PREPARED FOR THE PLAN COMMISSION

Project Address: 3722 Speedway Road (District 5 – Ald. Vidaver)
Application Type: Conditional Use
Legistar File ID #: [82116](#)
Prepared By: Chris Wells, Planning Division
Report Includes Comments from other City Agencies, as noted
Reviewed By: Kevin Firchow, AICP, Principal Planner

Proposal Summary: The applicant proposes to construct a four-story, mixed-use building with approximately 760 square-feet of commercial space and 31 apartments.

Image 2 – The Bulk Transition of the Proposed Building as seen on the Northeast Elevation (left) and West Elevation (right)

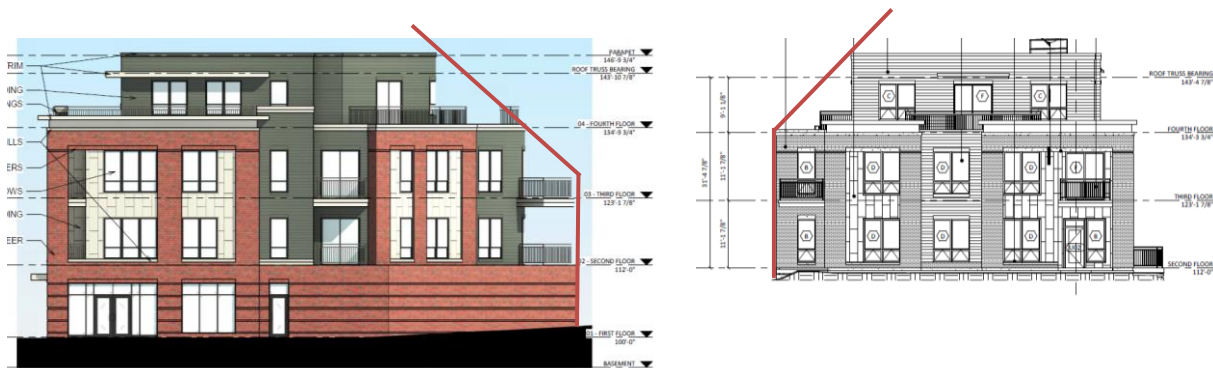
Based on the review by City Zoning, the current proposal would satisfy the side yard height transition to the residential district to the north, in this case the parcels located at 321 Glenway Street and 320 Waverly Place which are both zoned Traditional Residential – Consistent 2 (TR-C2) District and contain one- to one-and-a-half-story single-family residences. As MGO §28.064(3)(d) reads, “Where the NMX District abuts a residential district at the rear or side lot line, building height at the rear setback line (in this case, 6 feet) shall not exceed two (2) stories/twenty-five (25) feet. From this point, building height may increase at a ratio of one foot of rise to one foot of horizontal distance away from the property line, (a 45° angle) up to the maximum allowed height. Transitions exceeding this height and/or ratio limitation require conditional use.” Examining the submitted elevations, both the west elevation as well as the northeast elevation show the building’s compliance along the northern property line (see the transition requirement indicated by the red lines in the images below).
